Docket Item # 7
BAR CASE # 2009-0185

BAR Meeting
October 7, 2009

ISSUE: Signage & Awning
APPLICANT: Columbia Firehouse Restaurant
LOCATION: 109 South Saint Asaph Street
ZONE: CD/Commercial

Figure 2: Proposed front window sign.

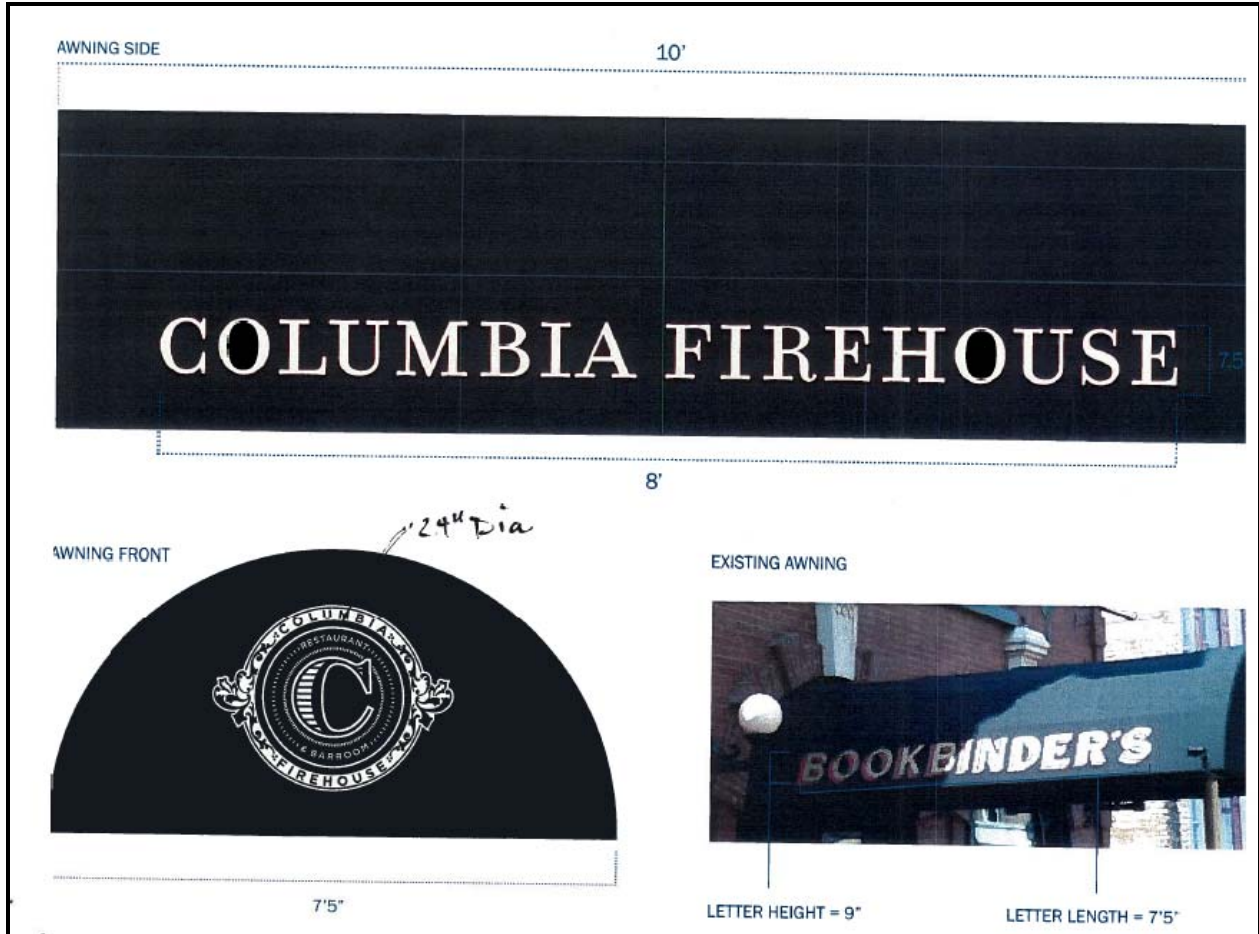
Since the item was deferred from the September 16, 2009 BAR hearing the applicant has revised the proposal and submitted additional information. The proposed signage on the bottom of the window was removed, leaving only the restaurant logo on the window, as had been previously recommended by Staff. In addition, the applicant provided photo simulations showing the proposed menu boxes proposed for either side of the restaurant's entrance.

The applicant proposes to replace the black fabric on the existing awning frame with a new black Sunbrella awning with signage. Both sides of the awning will contain the name of the restaurant, COLUMBIA FIREHOUSE. The white signs will measure 10 feet by 7.5 inches (for a total of roughly 12.6 square feet for both signs). At the end of the awning facing South Saint Asaph Street, there will be the restaurant's decorative logo, which will be 2 feet in diameter. The logo consists of a large "C" in the middle surrounded by the words "Restaurant & Barroom" and "Columbia Firehouse" on the outermost ring. The logo is primarily white with a thin burgundy outline. The same logo will also be installed as a frosted image on the front window of the restaurant. This logo will also be 2 feet in diameter.

1. That the menu boxes be sized such that they can be installed without obscuring the historic brick quoining around the restaurant's window and door;
2. That the menu boxes be painted black to match the building's trim;
3. That the menu boxes not be illuminated;
4. That the design and location of the menu boxes be subject to Staff approval;
5. That the text considered "special advertising" on the restaurant's front window be deleted; and,
6. That only the restaurant's logo be permitted on the front window.
